To: T10 Technical Committee
From: Rob Elliott, HP (elliott@hp.com)
Date: 29 September 2002
Subject: 02-393r0 SAS Port layer rewrite

This rewrites the port layer proposed in 02-202r4. Changes include:

Figure 2. Port layer Overall Control (PL_OC) state machine

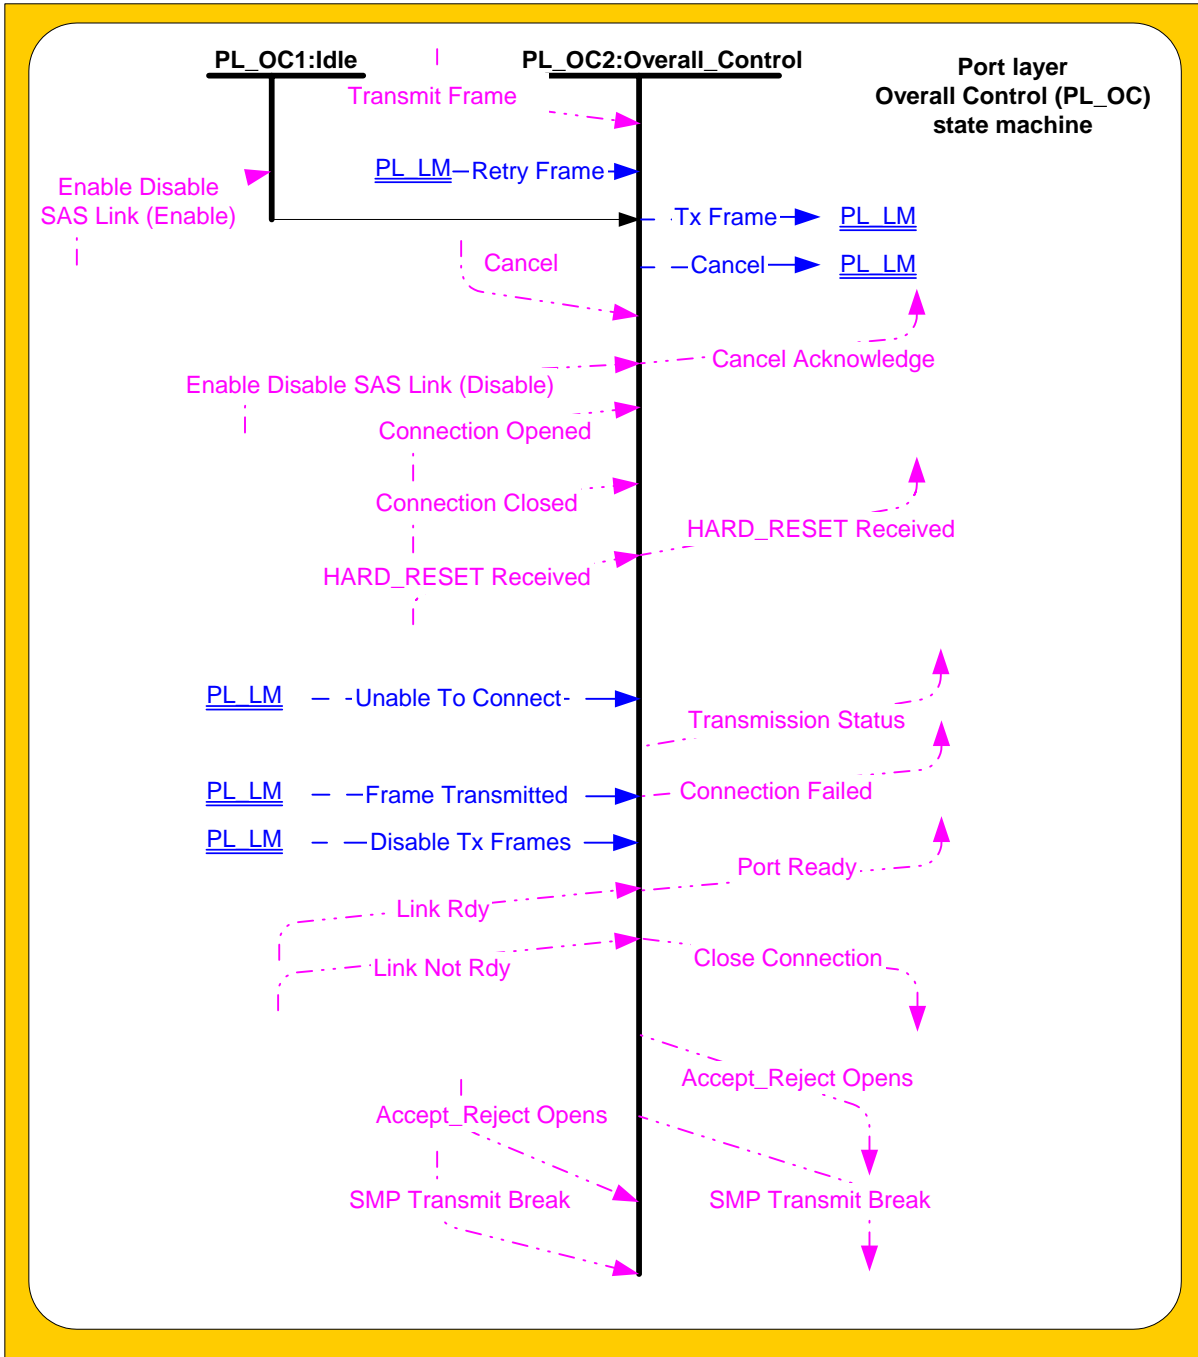
- a) remove PL_OC2 (SelectPhy) - let PL_OC1 select the request and phy in concert
- b) remove PL_LM4 (Check I_T Nexus) - let LM2 consider the I_T nexus loss timer and make all the Retry Frame decisions
- c) remove Maximum Burst Size and First Burst Size counters from this layer - they belong in higher layers that decide which frames to send
- d) let PL_LM manage Maximum Connect Time and Bus Inactivity Time timers since it owns the Connected state
- e) let PL_OC enforce the 15 us Retry Delay - if PL_LM does so, it prevents other requests from using the phy
- f) change how Arbitration Wait Time/Pathway Blocked Count are updated
- g) use "phy" rather than "link" when referring to the phy object
- h) lots of editorial rewording into standardese

- a) PL_OC1:Idle; and
- b) PL_OC2:Overall_Control.

The state machine shall start in the PL_OC1:Idle state. The state machine shall transition to the PL_LM1:Idle state from any other state after receiving an Enable Disable SAS Link (Disable) parameter from each of the link layers (see 7.8.4).
